PHASE 2 - WESLEY BRADLEY PARK

Vertical sidebar containing title block information: Title: COVER SHEET FOR CIVIL PLANS PHASE 2 - WESLEY BRADLEY PARK; For: WESLEY HOMES 815 SOUTH 216TH STREET DES MOINES, WA 98190 (206) 870-1209; Scale: Horizontal 1" = 80', Vertical N/A; Job Number: 16718; Sheet: C1 of C21; Date: 5/17/24; Designer: CK; Drawn: BOK; Checked: CMV; Approved: DKB; Date: 5/17/24; Professional Engineer Seal for Dan Balmelli, No. 25672, State of Washington, expires 5/17/24; Property Address: 707 39TH AVE. S.E. PUYALLUP, WA 98374.

Job Number: **16718**
Sheet: **C6** of **C21**

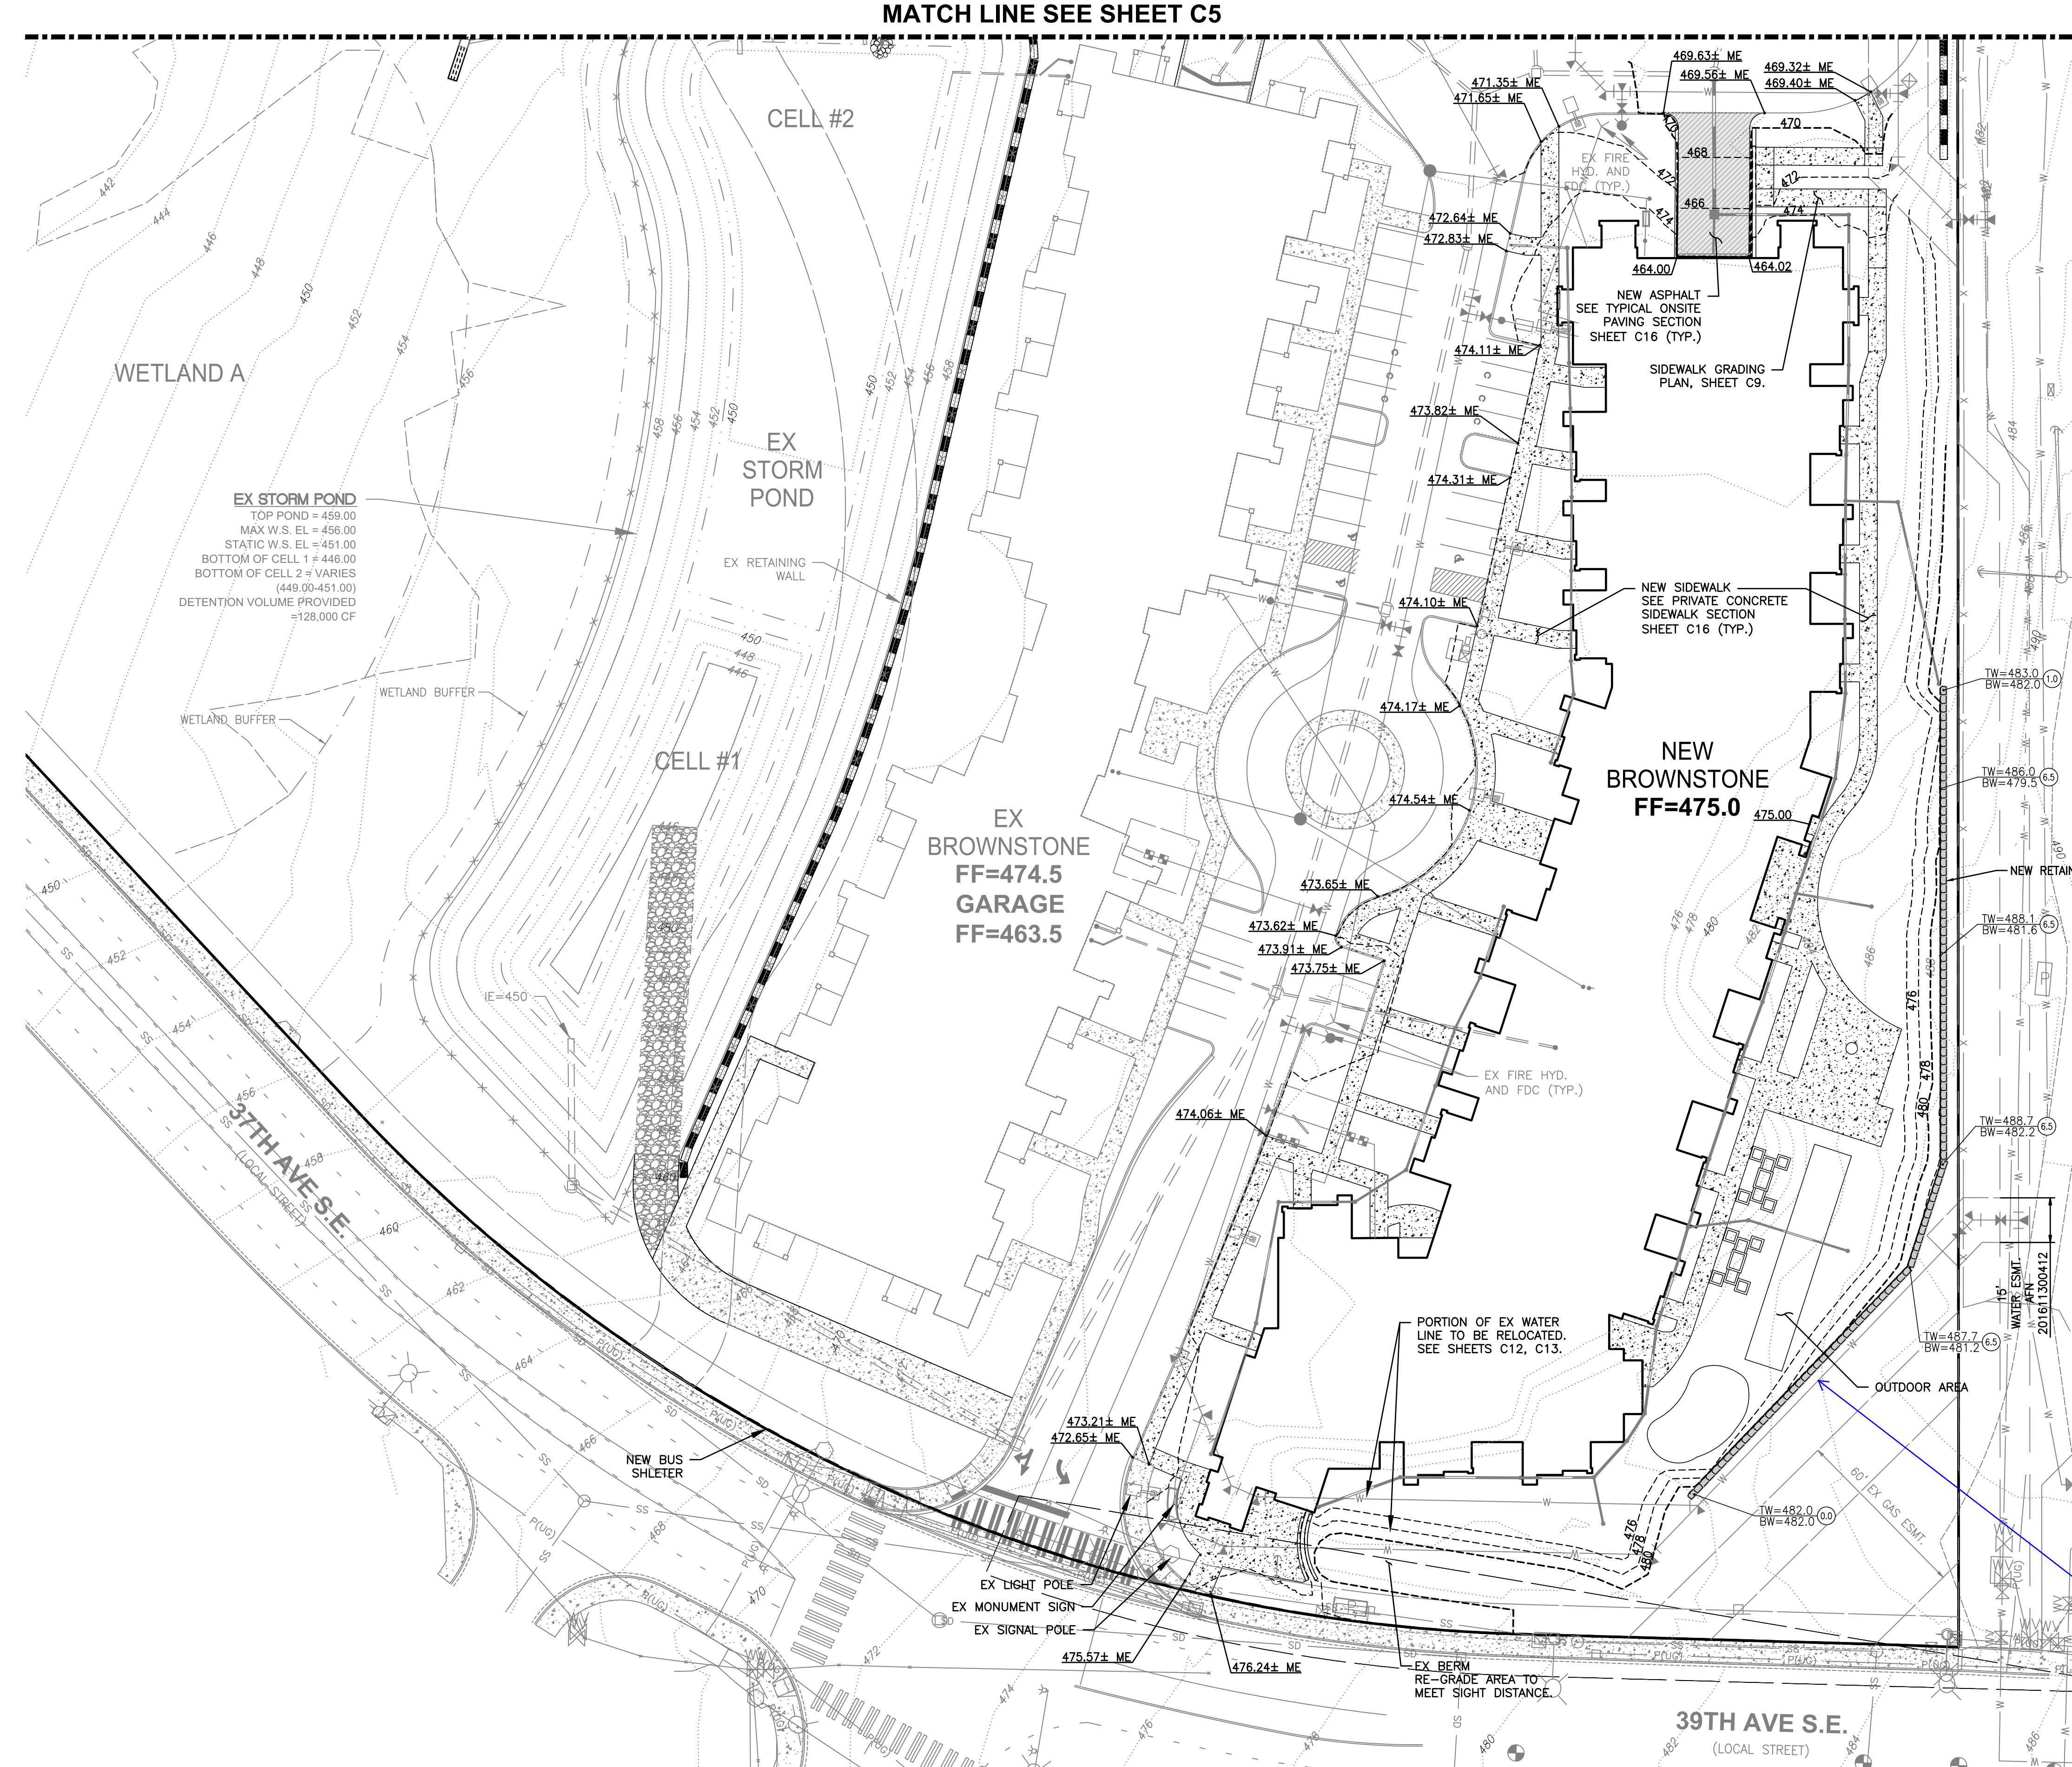
Revise-City standards requires a minimum 10ft separation of watermain to foundations. However, the City is willing to allow 5ft min separation between the retaining wall and main. [Plans: Sht C6 of 21]

Job Number: 16718
Sheet: C11 of C21

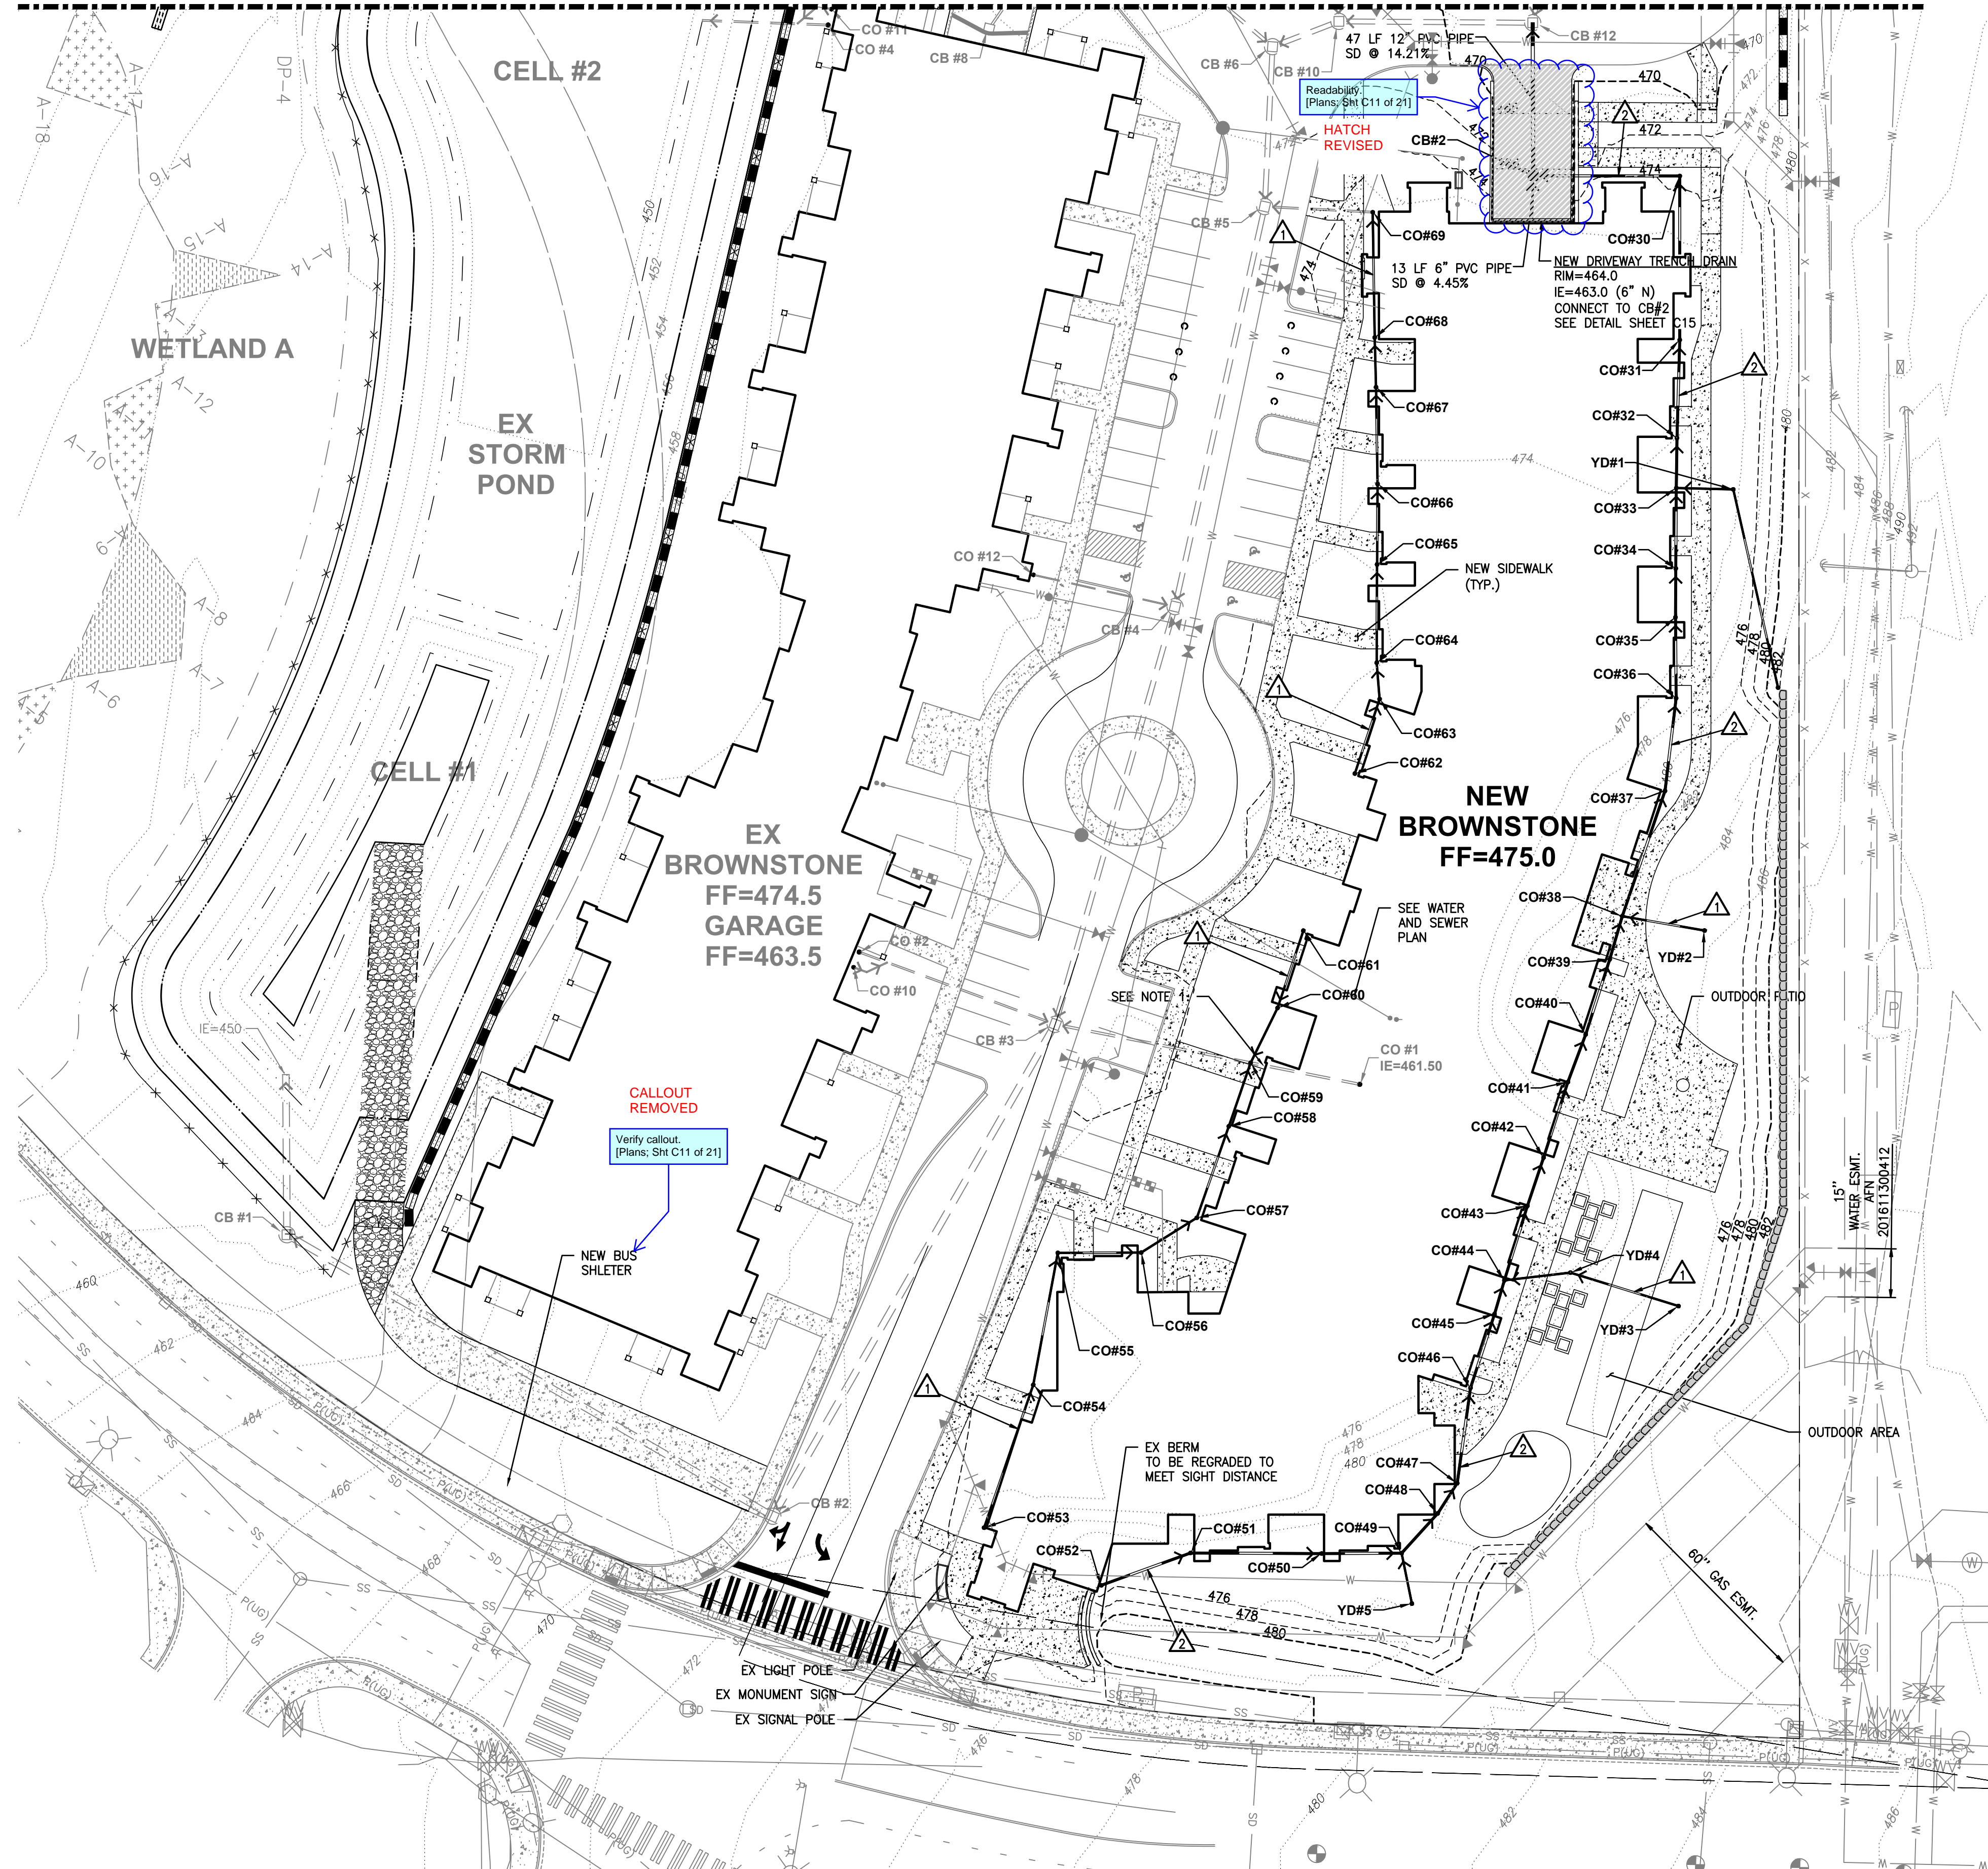
Show on plan.
(Plans: Sht C11 of 21)

CLEAN OUT
NOW CALLED
OUT IN PLAN
VIEW

DISPERSION TRENCH TYPICAL SECTION
NOT TO SCALE

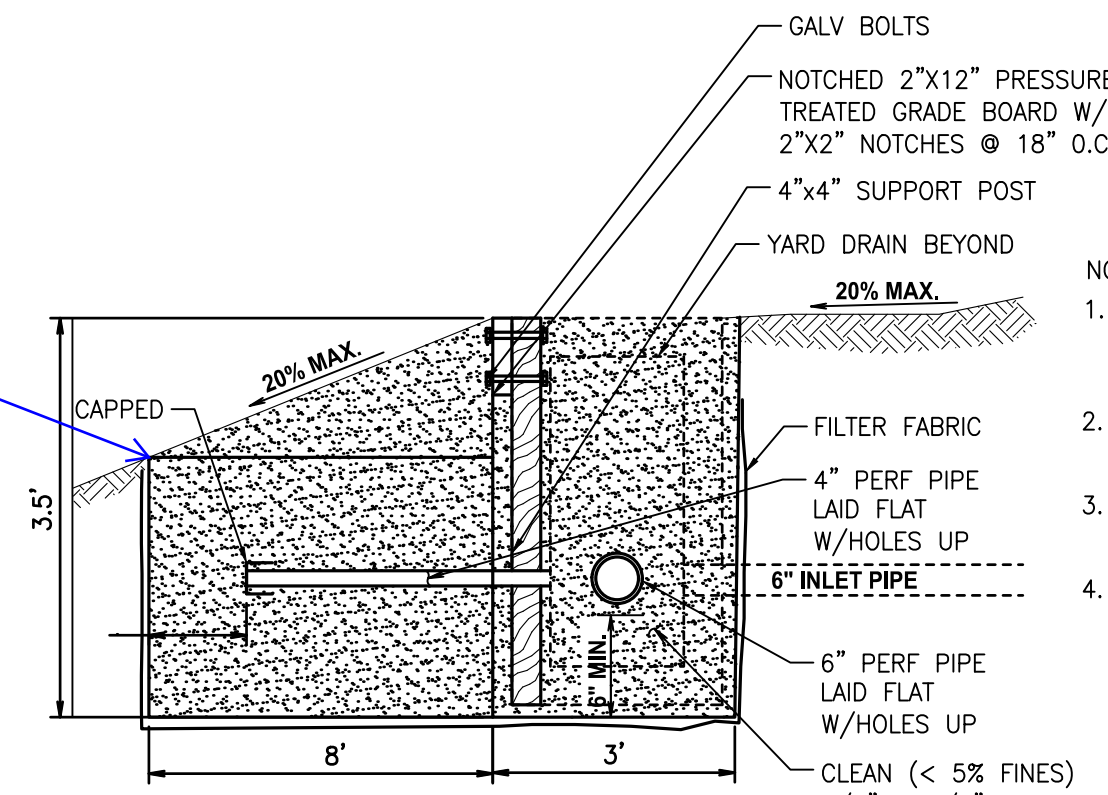
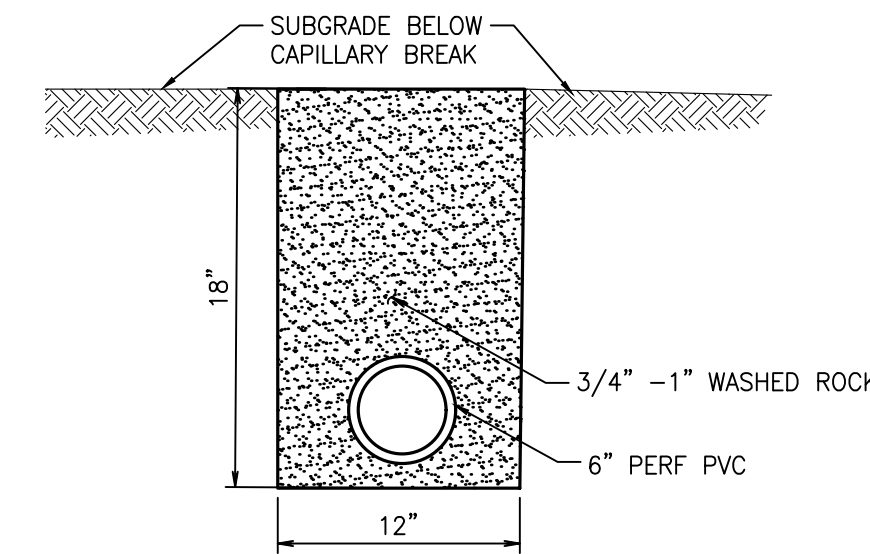
Clarify-shouldn't there be a grade board at this downstream location? As the trench section fills up, water will begin to spill out of the trench section at this lower elevation before reaching the top of the grade board as shown. Also, it seems this configuration would also allow water to spill over the sides of the 8ft trench extension before filling up the remainder of the trench resulting in concentrated water being discharged down the slope. [Plans: Sheet C16 of 21]

CITY OF PUYALLUP
DOWNSPOUT DISPERSION
TRENCH DETAIL ADDED, PLAN
REVISED.
